NOTICE OF MEETING

The City of Lake Elmo
Planning Commission will conduct a meeting on
Monday August 9, 2021
at 7:00 p.m.

**City of Lake Elmo
Planning Commission Meeting
Minutes of July 26, 2021**

GRADING PLAN

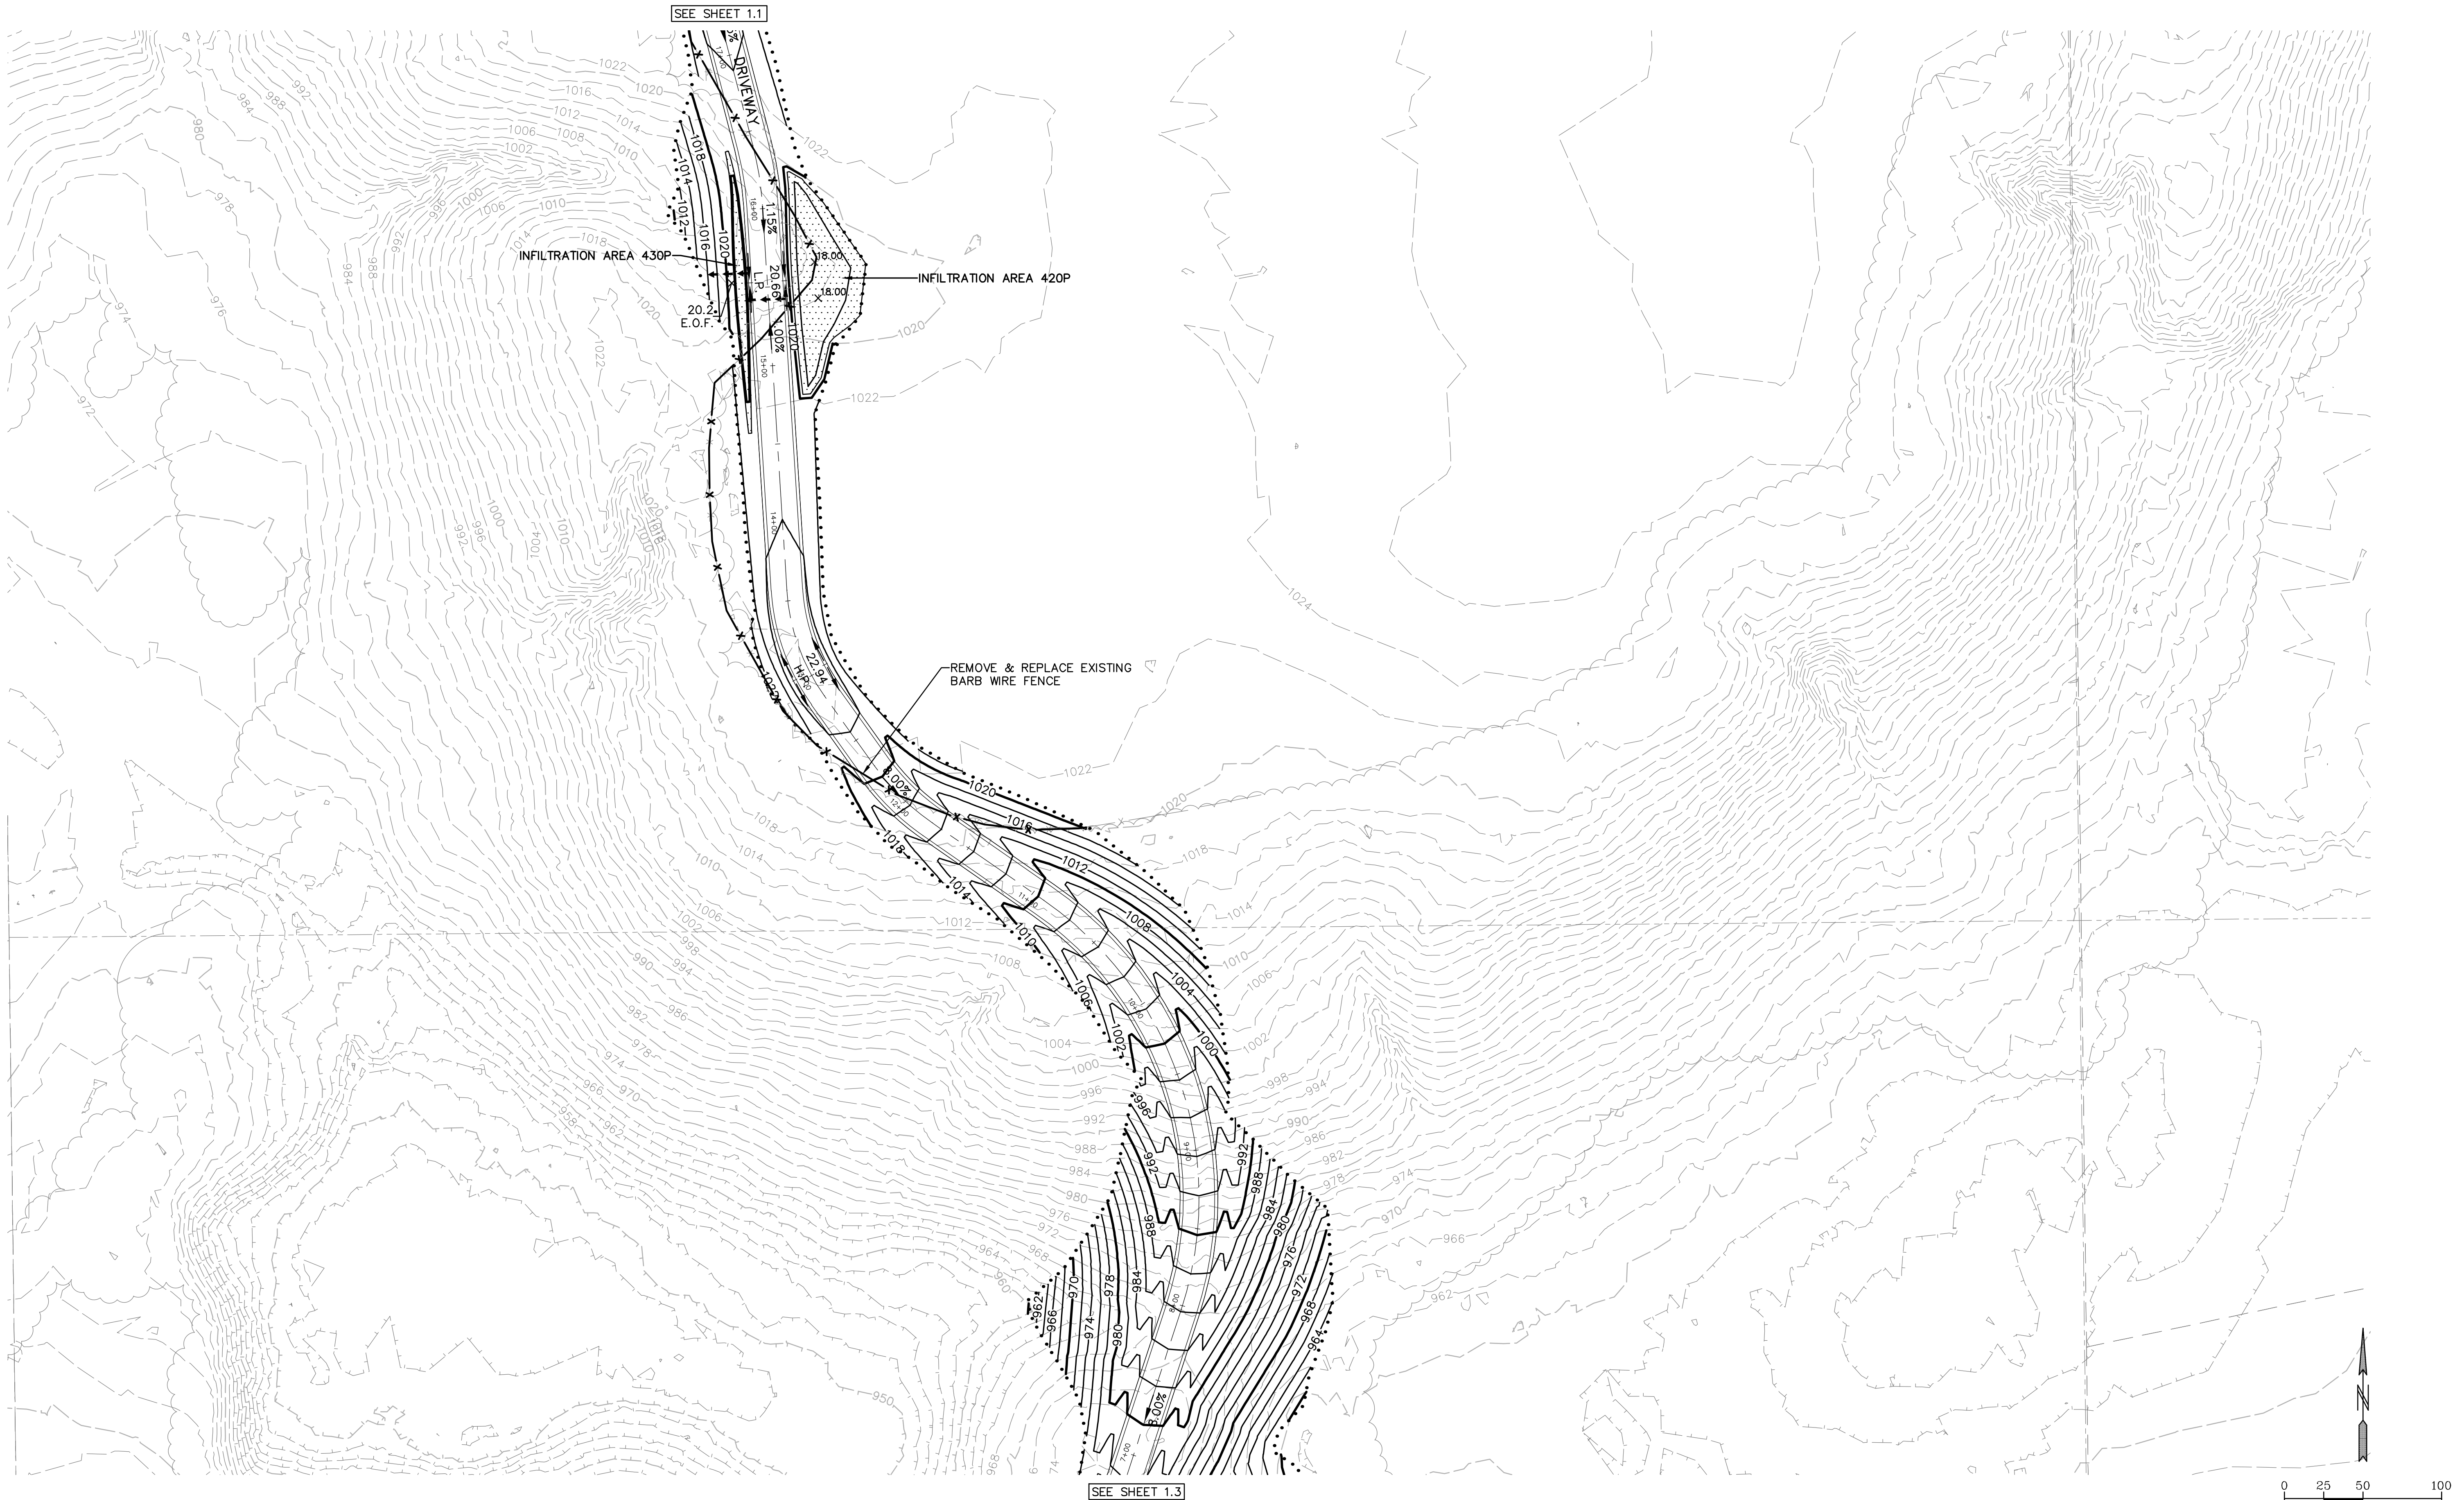
6. Sheet 1.1 – 1.3. Add culvert pipe size, material, and invert for all proposed and existing culverts.
7. Sheet 1.1 – 1.3. Add the 100-year HWL elevation and contour for all proposed infiltration basins. Add emergency overflow elevations and flow paths.

8. Sheet 1.1 – 1.3. Add proposed drainage and utility easements for each infiltration basin, incorporating the 100-year HWL elevation and contour, and maintenance access routes to all drainage structures.

9. Sheet 1.1. Revise grading plan to eliminate infiltration basin encroachments for areas 200P and 250P from the DeMontreville Trail right-of-way. Revise plans as needed to ensure the EOF flow path from 200P and 250P remain outside of the public right-of-way.

3.23 OF 28

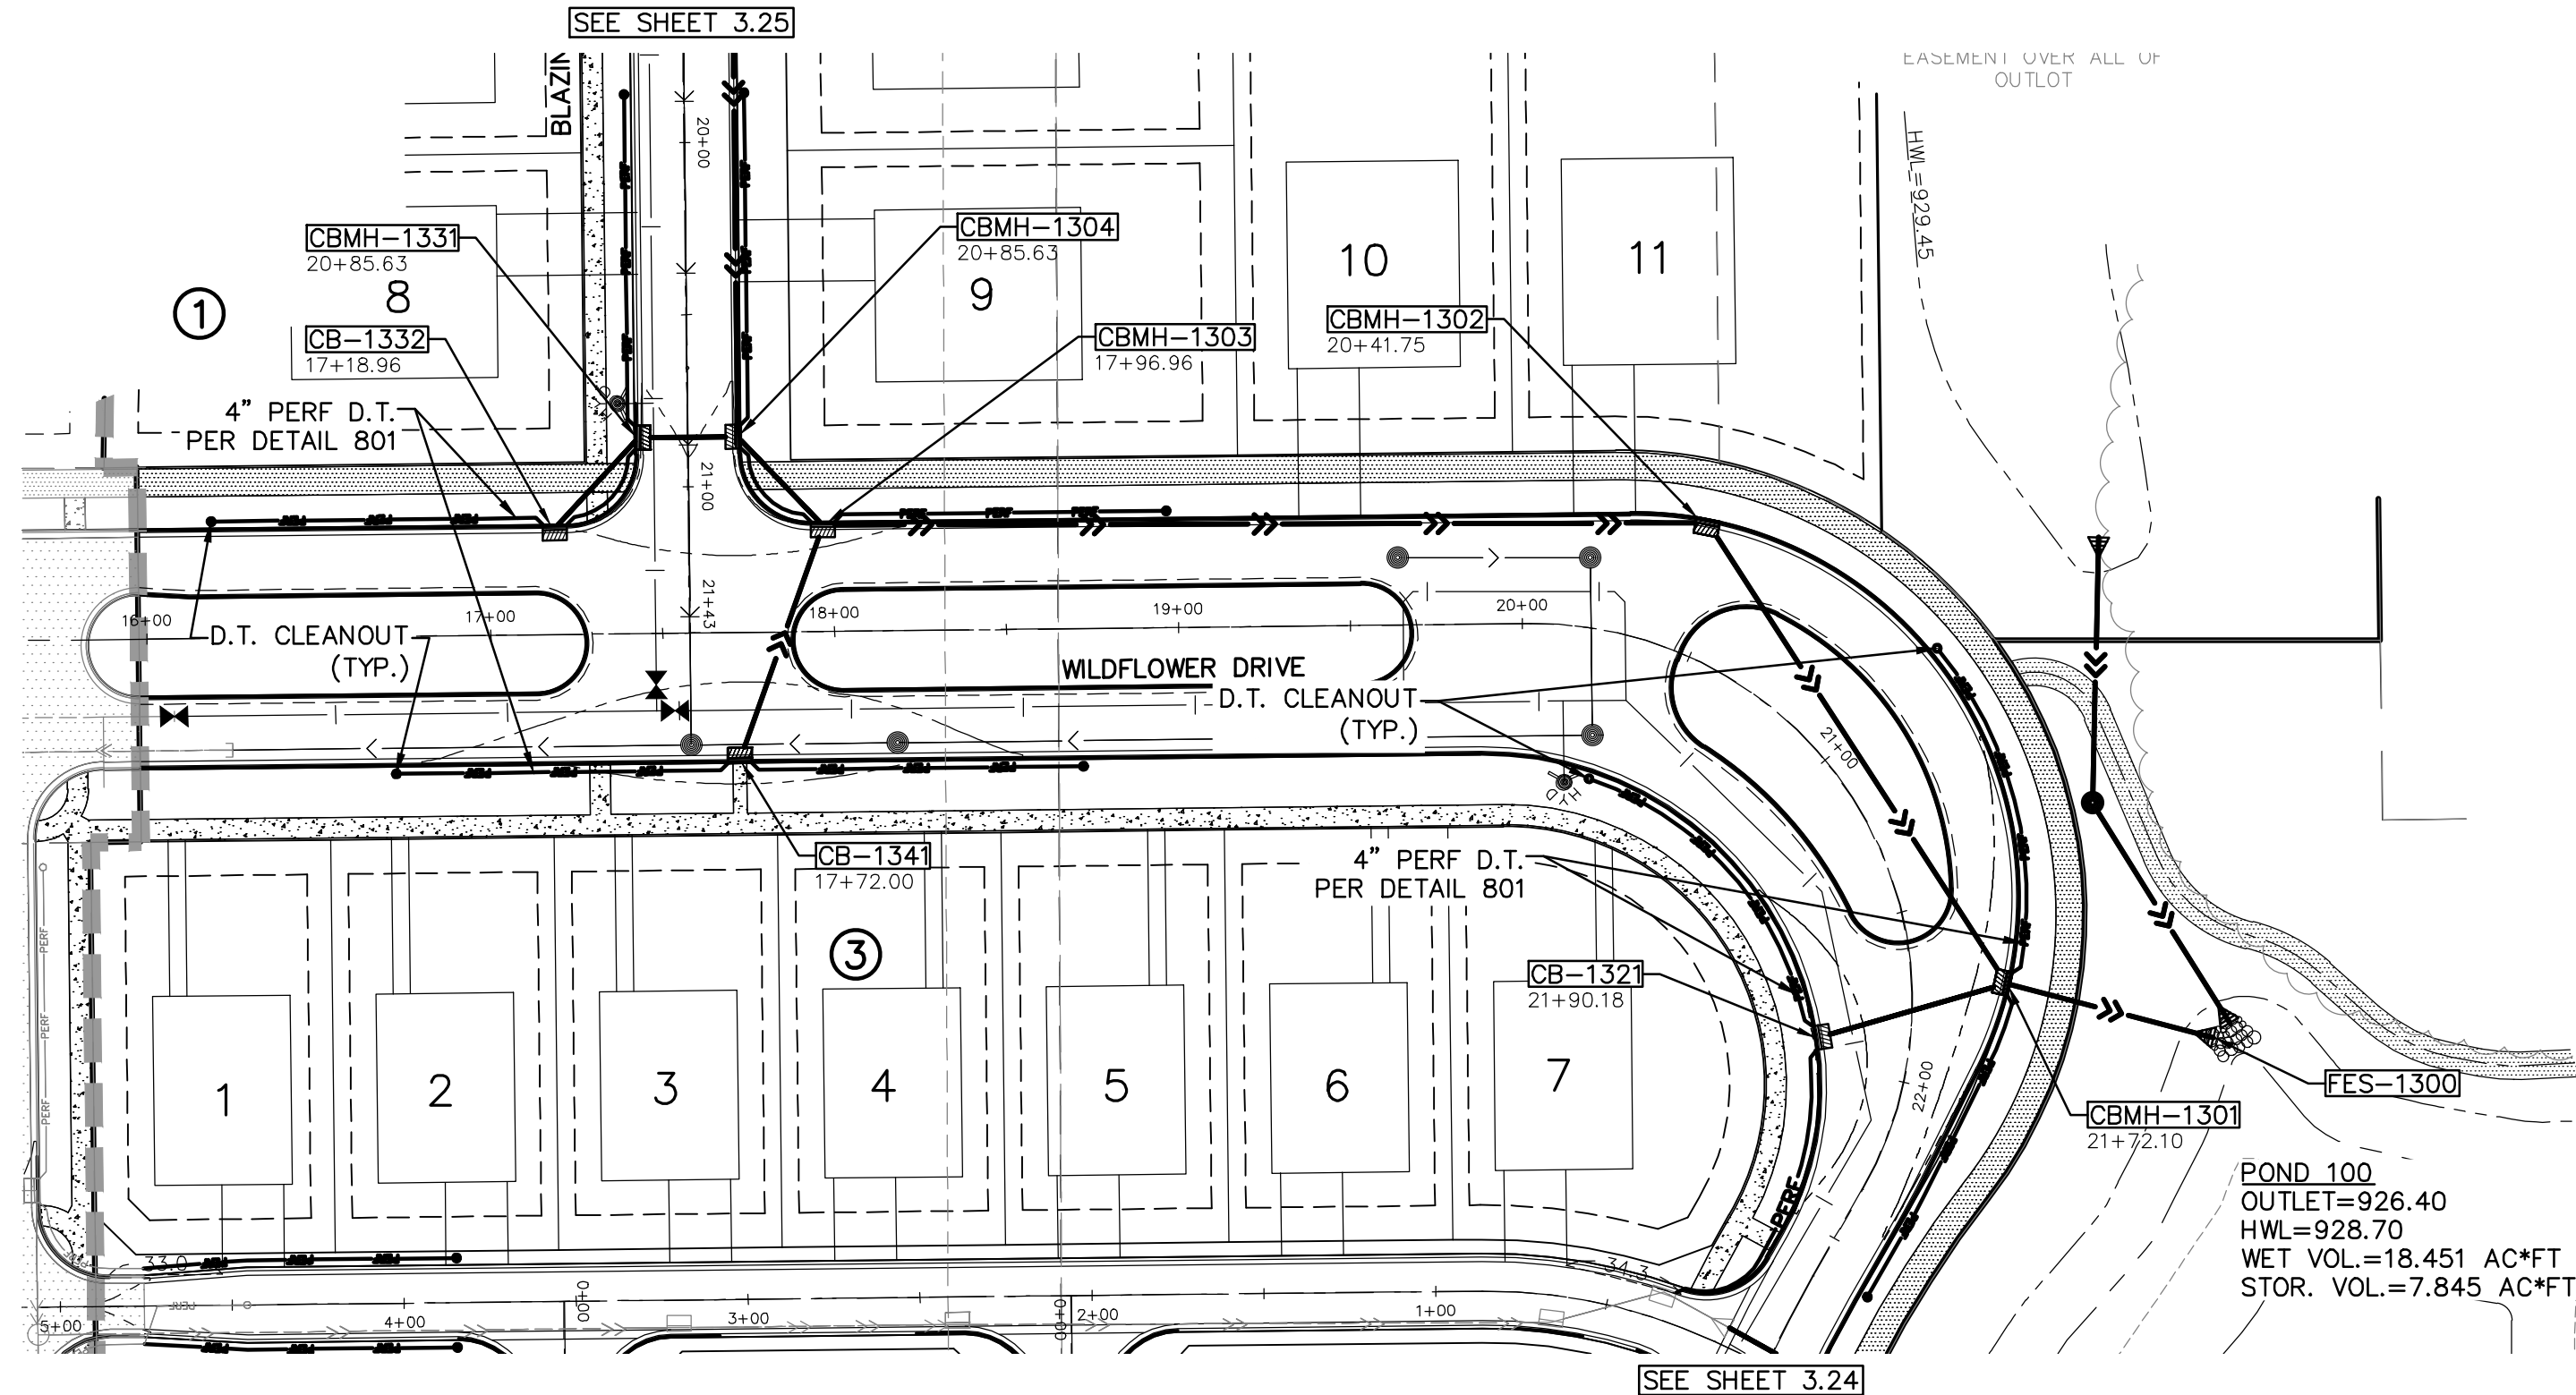
- Sheets 3.21-3.25. Replace Standard Plan Notes for Storm Sewer with City Plan Notes dated April 2019.
- Sheets 3.21-3.25. Revise plans along proposed storm sewer not placed in roadway corridors to show all existing conditions. Plans must identify all removals, protections, erosion control and restoration details.

3.31 OF 28

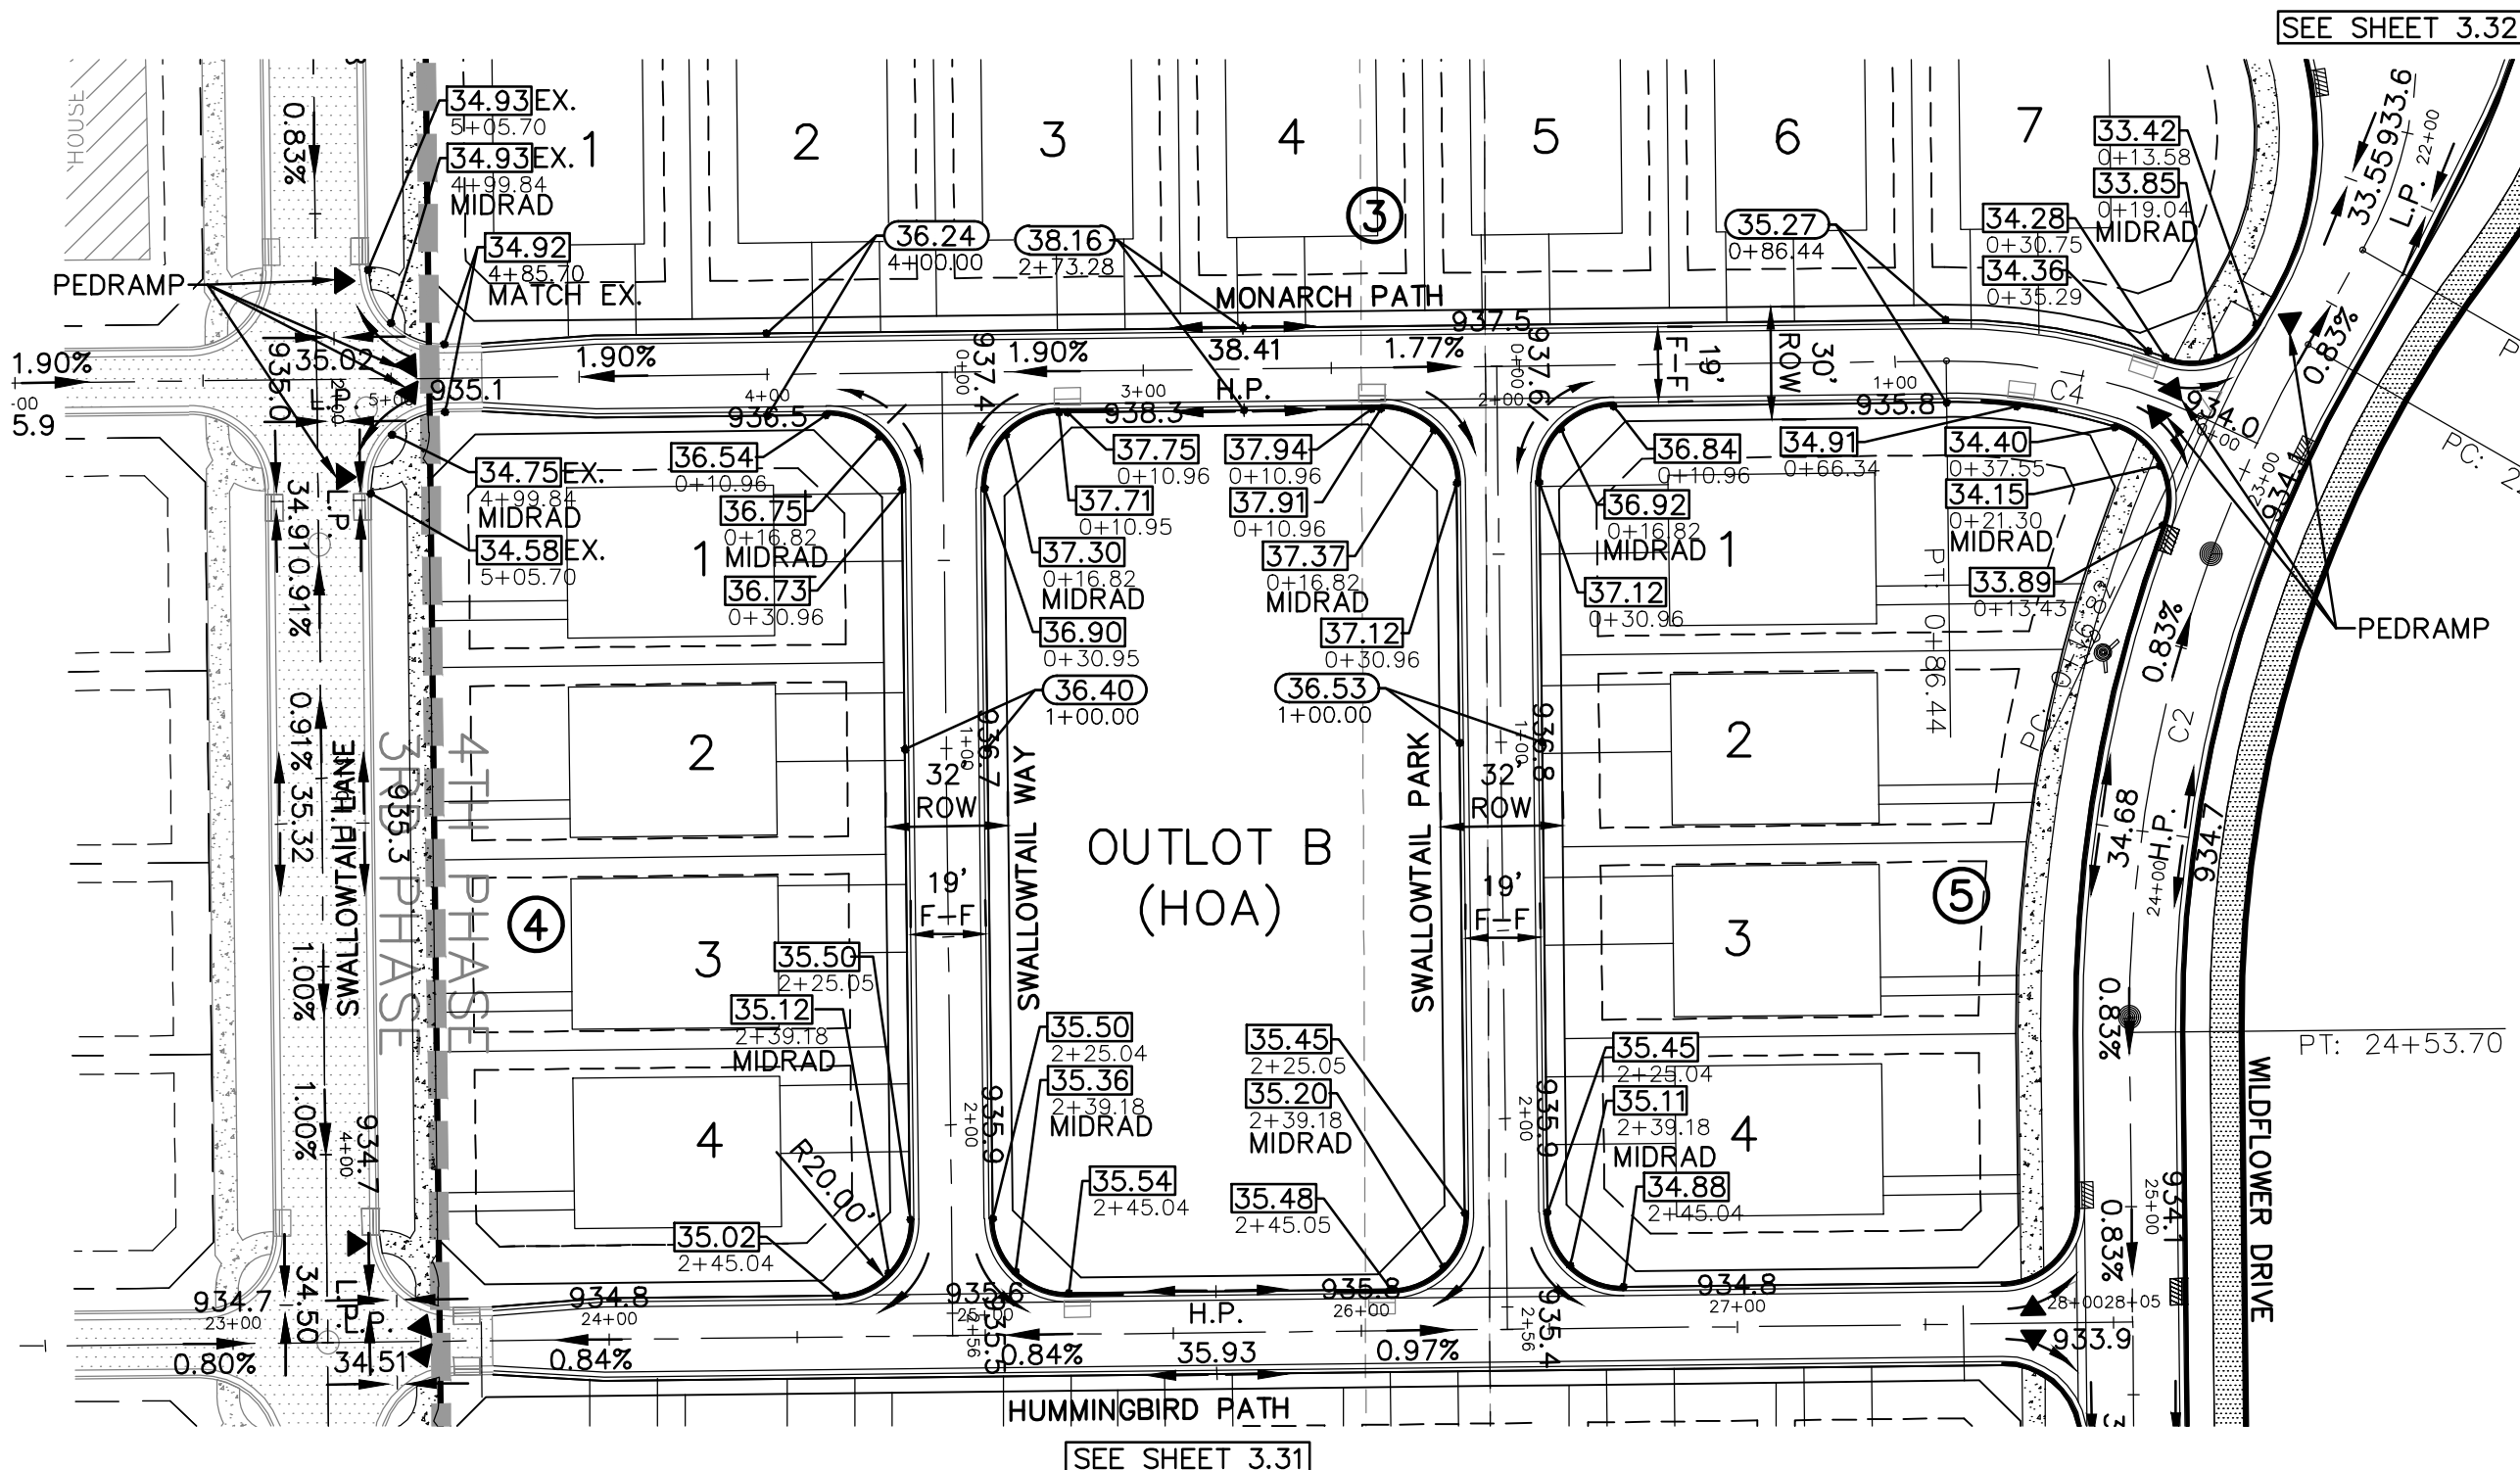
- Sheet 3.31. Revise typical section for Sunflower Lane and make all plan revisions accordingly.
 - Revise tree setback to city standard minimum 5-feet when sidewalk is along the boulevard.

- Sheet 3.31 and 3.32. Revise plan view to show location of sidewalk within the street right-of-way per the proposed typical section.
- Sheet 3.31. Revise typical section for 30'/32' ROW Street to create two separate typical sections and identify all applicable roadways by name to facilitate city review.
